Suspension Hitting LP Pipe

VIN Range Effected

North Trail Travel Trailers within the VIN range of 5SFNB3425AE209605 to 5SFNB3620BE227945 with these specific floor plans: 26LRSS, 29BHSS, 29RBSS, 31BDSS, 31RESS, 31RKDS, 32BUDS, and 32QBSS.

Parts

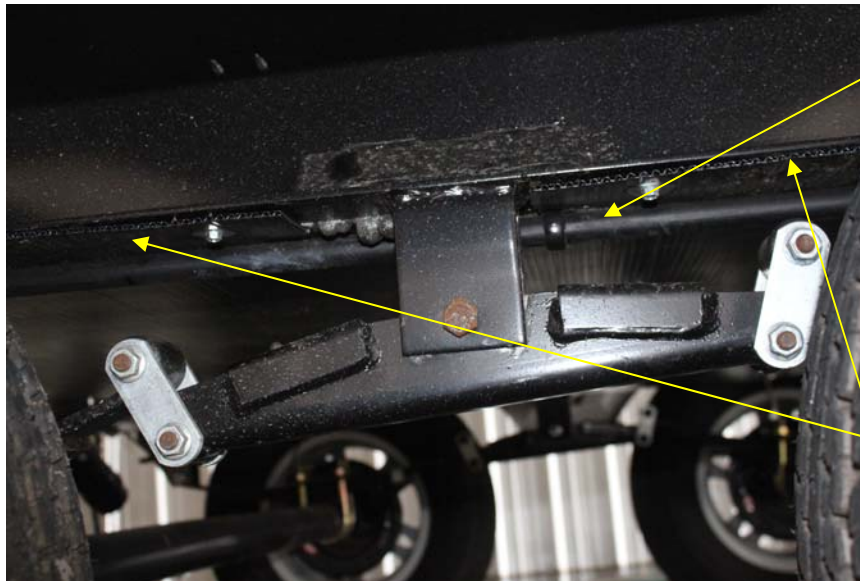
Recall kit part # 82902 which consists of 2 bumpers and 2 - 5/16"x18x1.25" washer head hex slot bolts.

Drill pilot hole in frame.

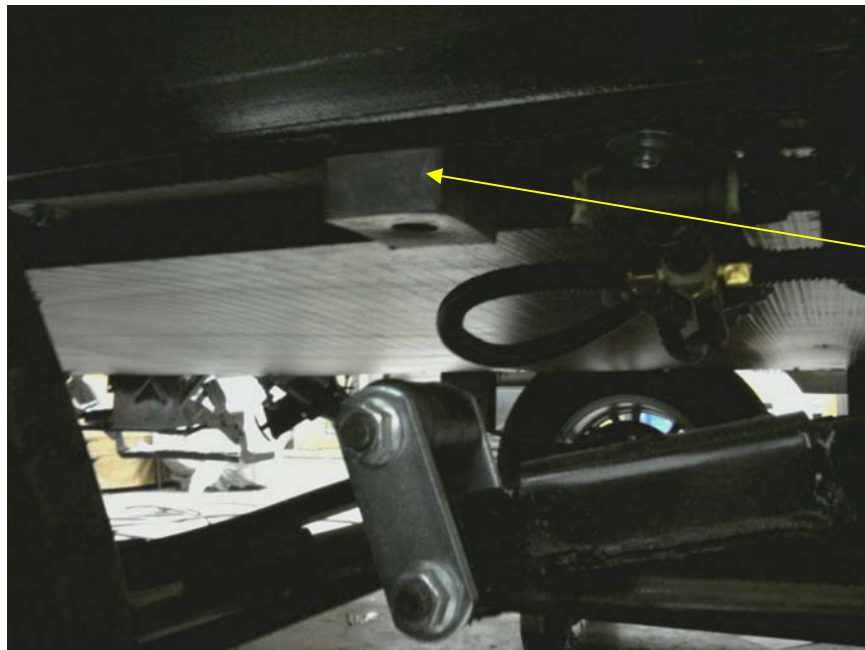
2. Mark your location on frame and drill a 9/32" pilot hole in frame to mount bumper. Pilot hole should be as close to the center of I beam as possible. You may need to trim back the underbelly to get a good mount location.

- Using the provided bolts attach the bumper to the frame.

- Location of bumper after mounting.

- Repeat on the other side of equalizer. File claim
